— Design Note

Client:	The British Museum
Project:	Health and Safety Lighting - External
Project No:	113
Date:	24 April 2024
Author:	Joe Dent

This design note has been produced to support the planning and listed building applications for new health and safety lighting at the British Museum.

Figure 2: View of existing colonnade steps

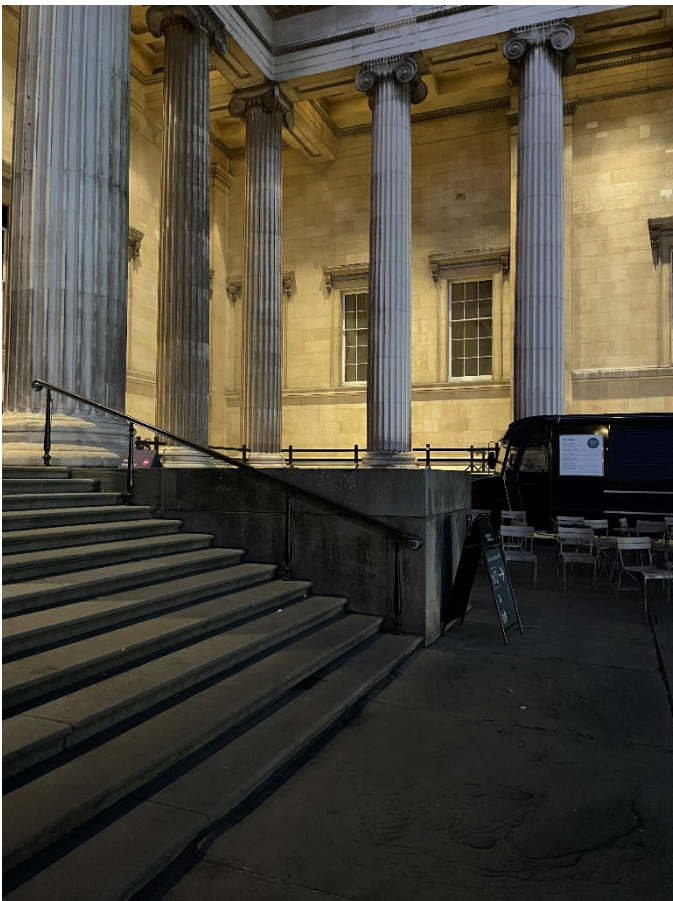
- 1. Concerns have been raised about the need for the spotlights to improve lighting/ illumination of the front steps as they appear to present a substantial and visual intrusive intervention at high level to achieve a modest improvement for a limited period of time over the course of the year. It would be necessary to justify the need for the improved lighting by providing evidence in the form of any data of reported falls / trips that have been received by the Museum by visitors using the main steps. We can then take this into consideration as part of our assessment of any new lighting proposal.*

It is worth noting that the south colonnade steps do not have any nosings or demarcation strips, and so are not compliant with the current Approved Documents of the Building Regulations. Of course, the steps heritage value provides good reason for them not to be harmed with additional nosings or demarcation, but we believe that taking the opportunity to improve their lighting in a sympathetic and reversible manner, provides benefit to users of the building within little to no harm to the building.

Figure 3: Diagram showing height of mock up flood light position and proposed flood light positions

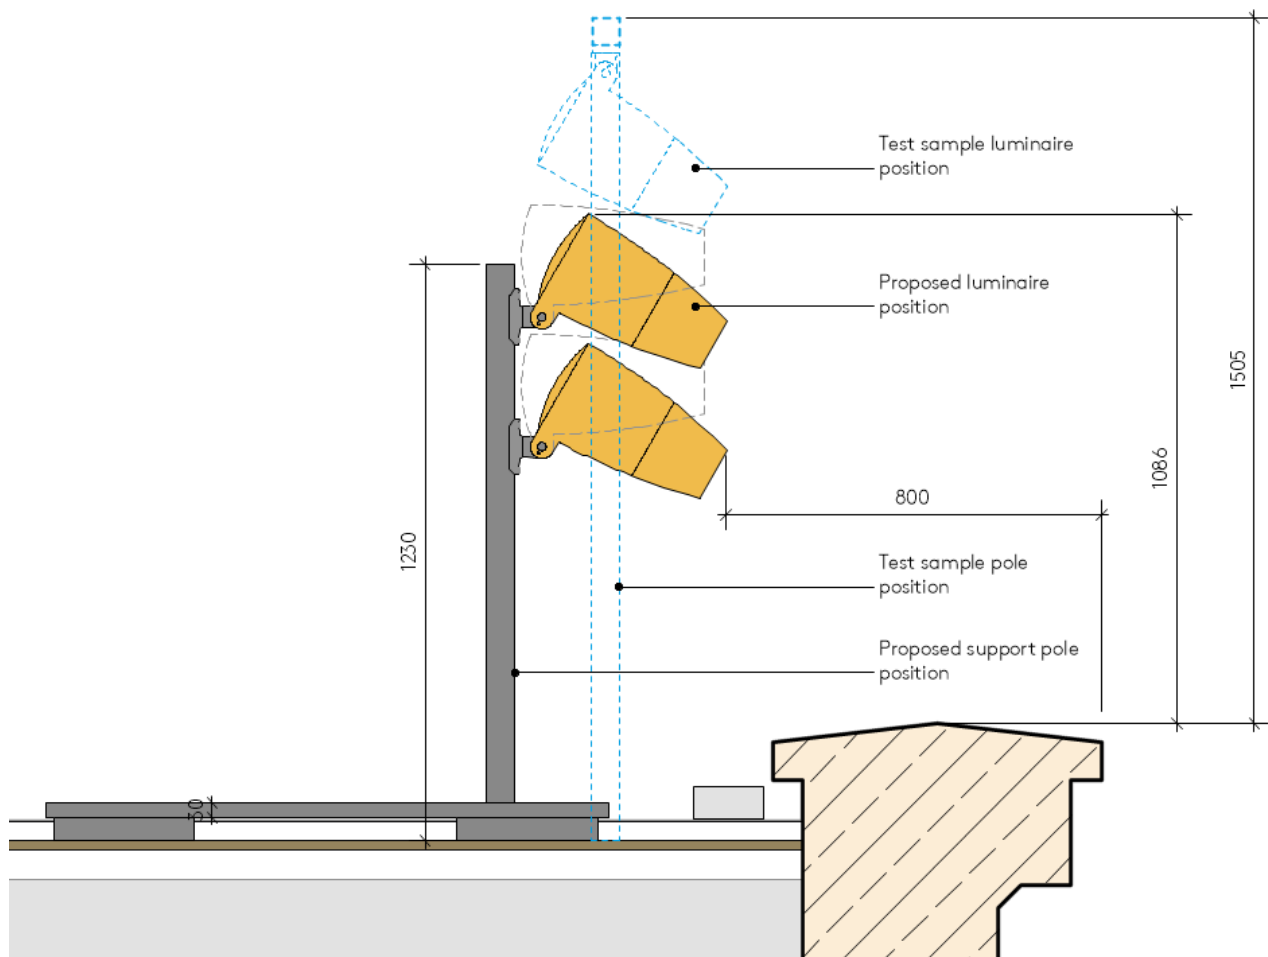
- 2. On site we talked about the possibility of reducing the height of the spotlights and moving them back from the parapet. Is it possible to submit the presentation that we received on 14th December as well as sketches showing the revised height and possible revised location of the spotlights for our consideration so that we can look at the proposal comprehensively. Some initial marked up floor plans and elevations would be enough.*

The new floodlights are proposed to be fitted closer to the coping line than the location that one was installed in for the mock up shown to officers, per the sketch below. The two lights on each roof will also be supported of a single pole on each side, rather than hanging from the temporary 'T' bar which the lights were fixed onto for the mockup. This, and the light grey tone of the fixtures and mounting pole will give the lights a subtle profile during the day.

At night, the lights will be directed across the south elevation, with deep honeycomb louvres shading the bulbs, meaning there will be very limited glare, especially when the elevation is viewed from the street and the southern areas of the south forecourt.
